## TECHNICAL NOTE

Project: DM/25/2634 - Batchelors Farm, Keymer Road – Additional Traffic/Transport Information

STAGE 1 ROAD SAFETY AUDIT  
RESPONSE REPORT

**BACHELORS FARM, KEYMER ROAD  
BURGESS HILL  
S278 WORKS  
STAGE 1 ROAD SAFETY AUDIT**

Drawing Number  
**SK21799-10**

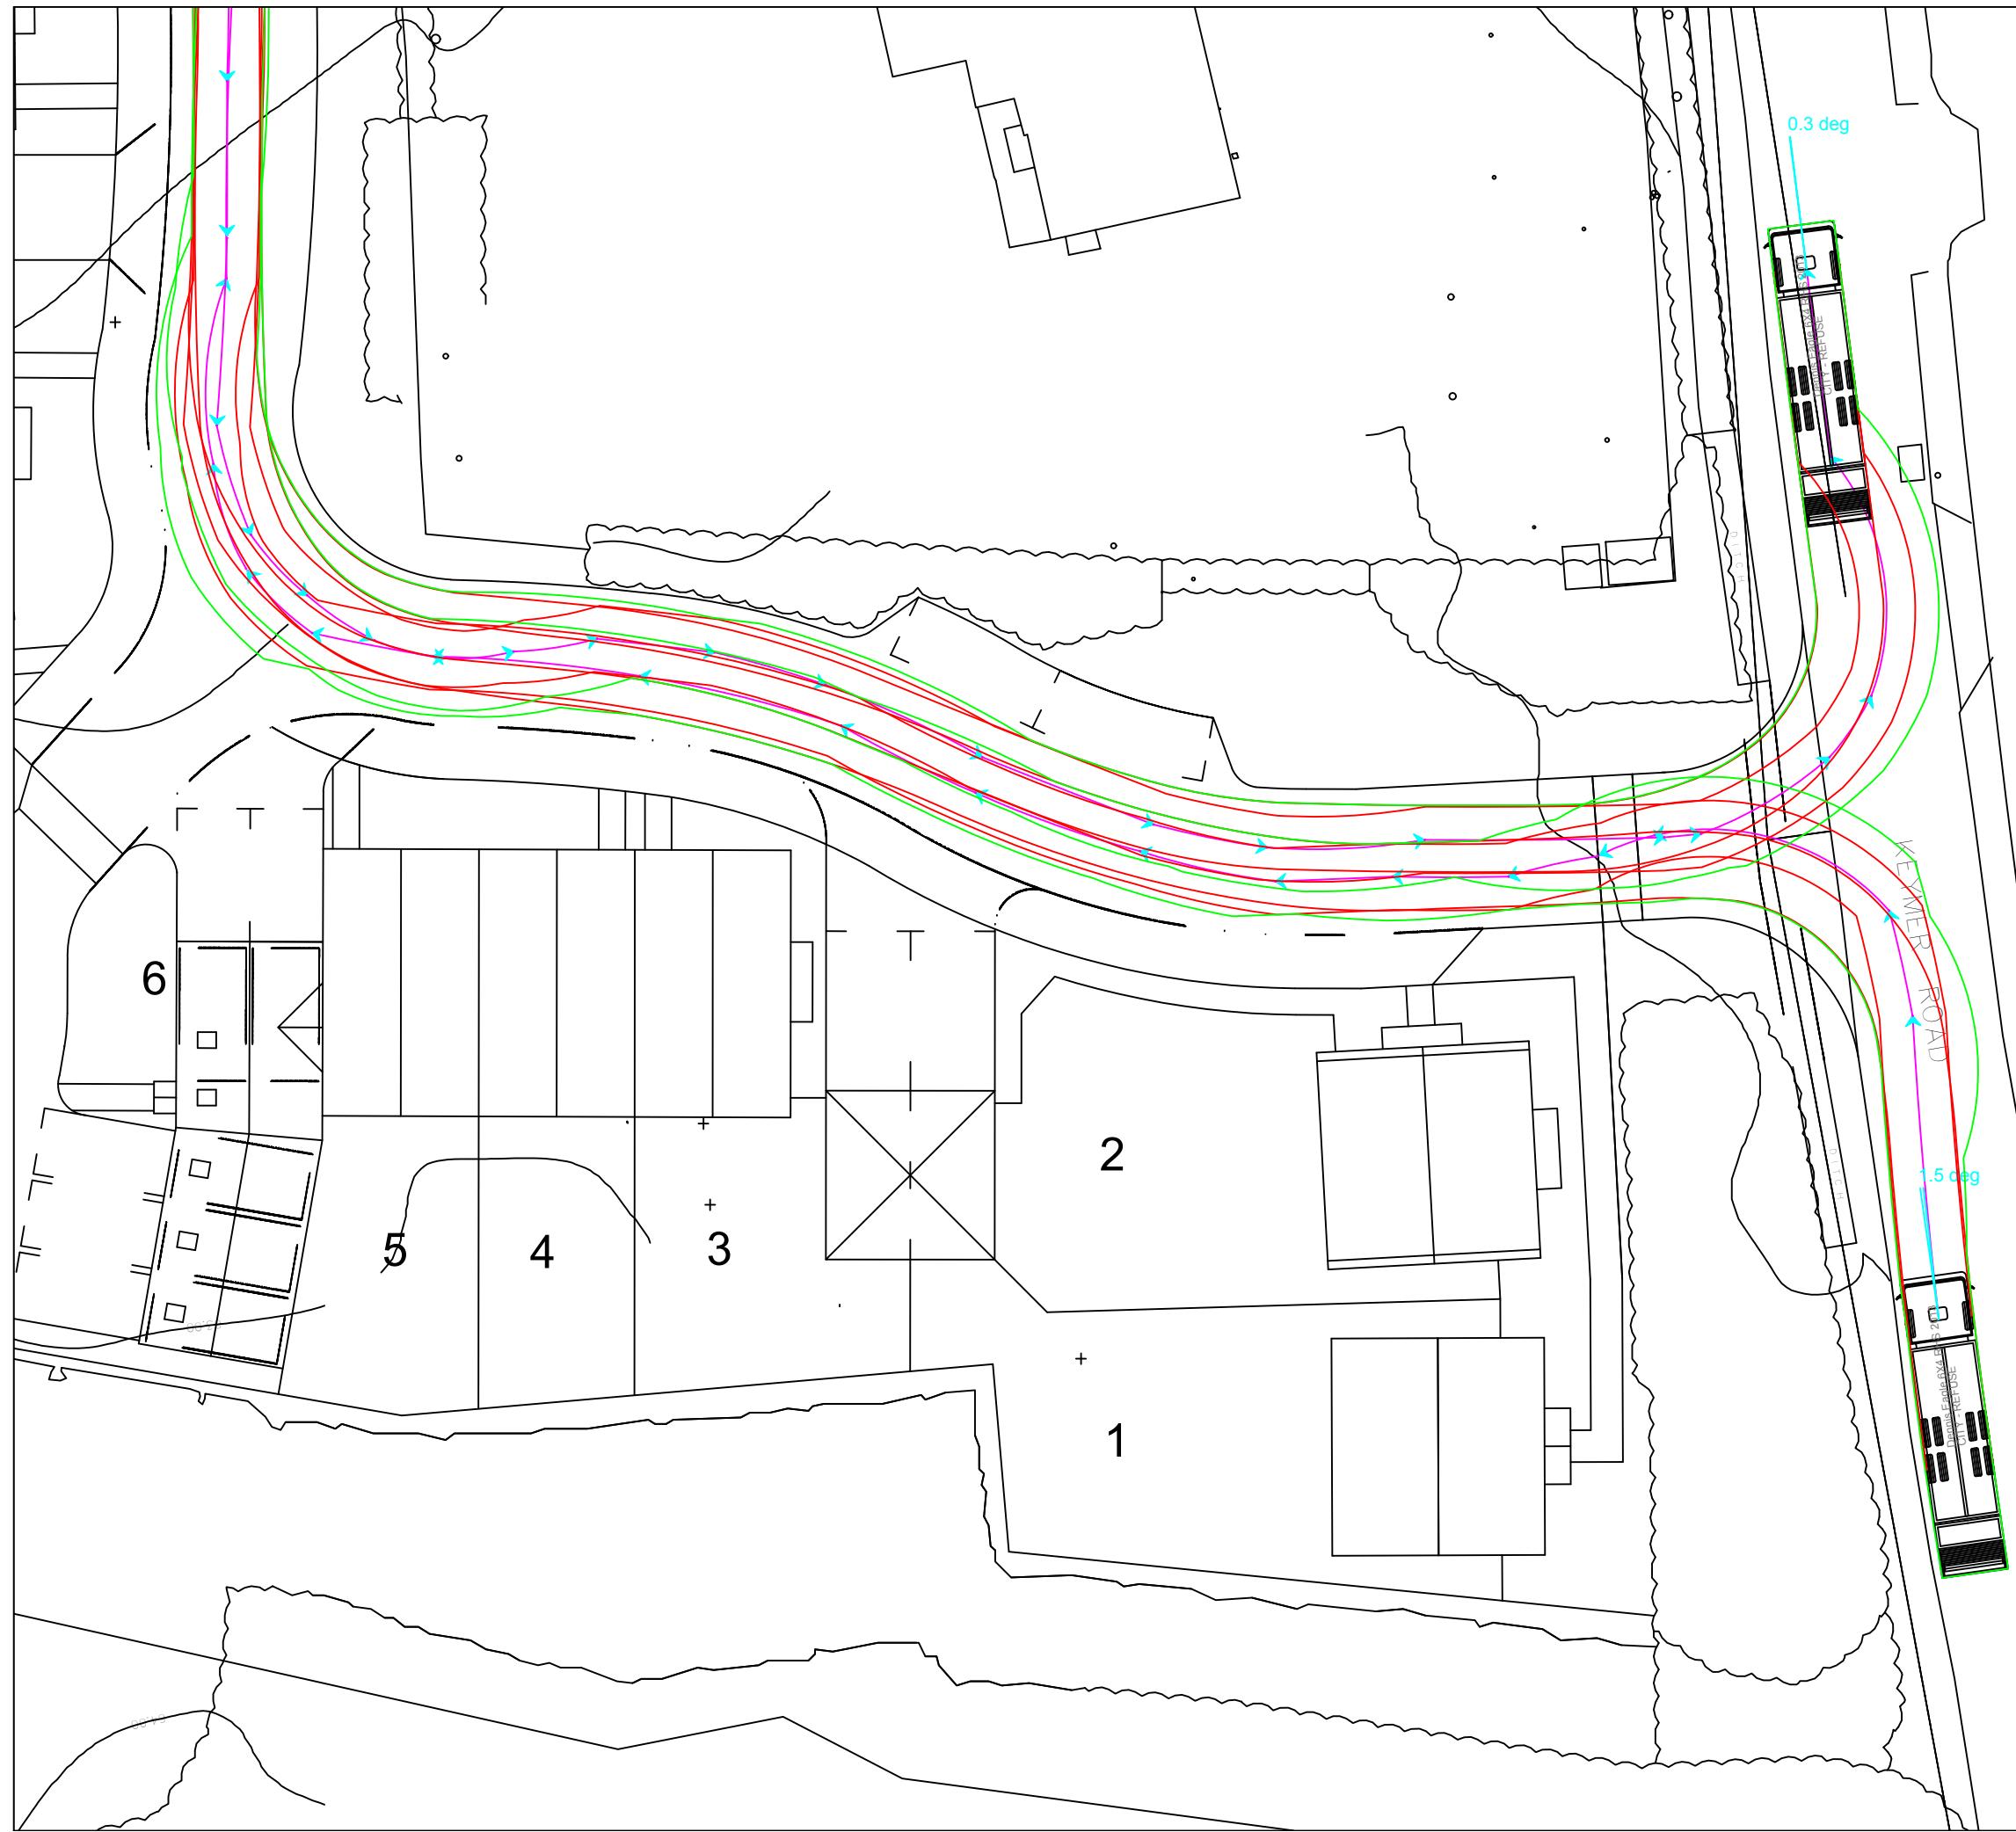
- a) Swept path tracking plans showing that the vehicle access can accommodate refuse collection and fire appliance vehicles, and that these can turn on site to exit in a forward gear

- 2.1 In response to WSCC's request, vehicle swept path analysis drawings have been prepared for the illustrative layout, to show that the development can accommodate an 11.3m refuse vehicle and fire appliance. These drawings are appended to this TN in **appendix b**, and are also appended to the Stage 1 Road Safety Audit (RSA), provided in **appendix c**.
- 2.2 The vehicle swept path analysis drawings confirm that these vehicles can enter and leave the site in a forward gear, without the need to overrun verges or footways. Whilst the final development layout will be fixed at Reserved Matters (RM) stage, this exercise confirms that a development of this scale can be accessed in an appropriate manner.

Revision Details	By	Date	Suffix
			Check
<b>Drawing Number</b>			
<b>SK21799-05 REV A</b>			
<b>Batchelors Farm</b>			
<b>Drawing Title</b>			
Agreed Pedestrian Access Enhancements with WSCC			
<b>Scale at A3</b>			
1:1000			
Drawn		Approved	
KAT		MAK	
Check		Date	
KAT		24/12/25

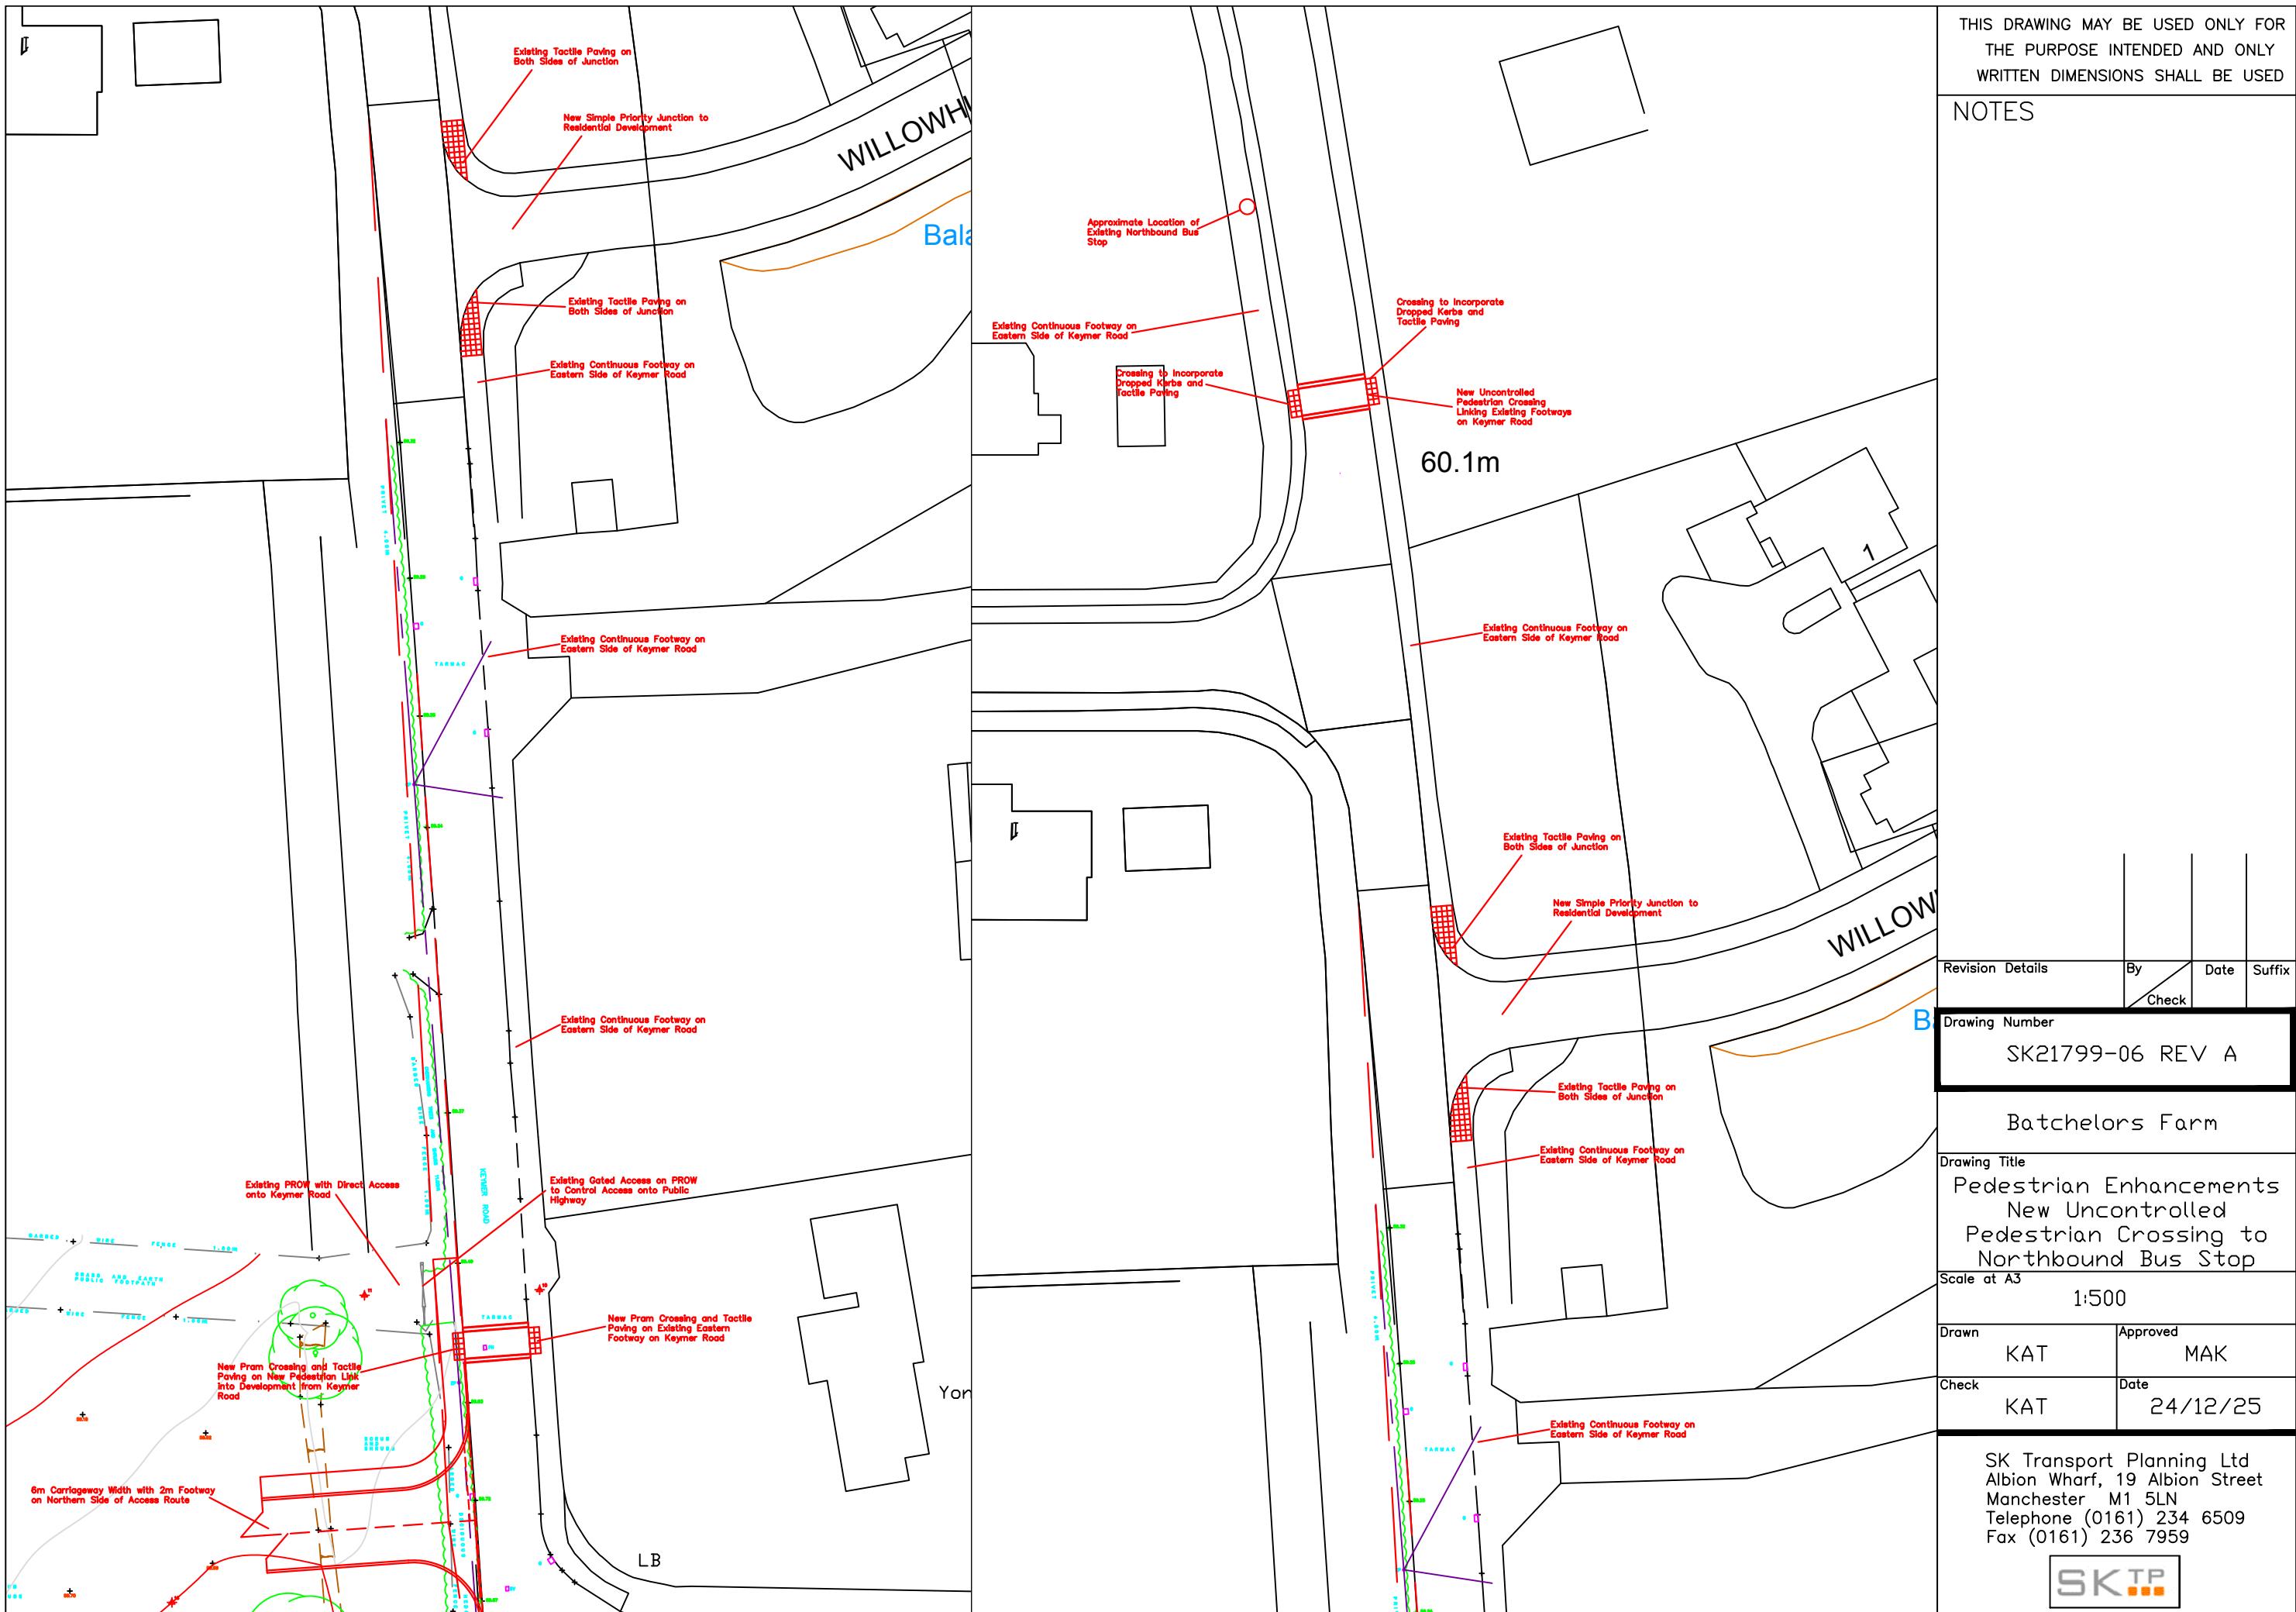
- b) a Travel Plan Statement (or can be secured along with the monitoring fee via a legal agreement)
  - c) consideration of a new footway on the western side of Keymer Road to link the north-eastern corner of the site to Greenlands Drive, including tactile paving across the existing dropped kerb of Greenlands Drive

- Travel Plan Statement (or can be secured along with the monitoring fee via legal agreement).
- Footway on western side of carriageway to link north east corner of site to Greenlands Drive, including tactile paving across existing dropped kerb of Greenlands Drive.
- Swept path tracking.
- Stage 1 RSA

2.7 Based on the above findings an alternative pedestrian access design was discussed and agreed in principle with WSCC Highway Officers. With the development already delivering an uncontrolled crossing in the north-eastern corner of the site, linking the development and existing Public Right of Way (PROW) with the footway on the eastern side of Keymer Road, pedestrians will be able to cross and then walk northwards towards the bus stop, crossing the recently constructed Thakeham development access.

2.8 After crossing this development access, there is the opportunity to cross back to the western side of Keymer Road, to the north of Greenlands Drive via a new uncontrolled crossing facility. This new crossing can be delivered by the proposed Batchelors Farm residential development.

2.9 This alternative pedestrian strategy is shown on the pedestrian access drawings included in **appendix d**. These have been the subject of a Stage 1 RSA, and following that review have been shown to be appropriately located, have the appropriate intervisibility for the speed limits on the corridor for pedestrians to safely cross and can be delivered by the development on land the applicant controls and/or the adopted highway.
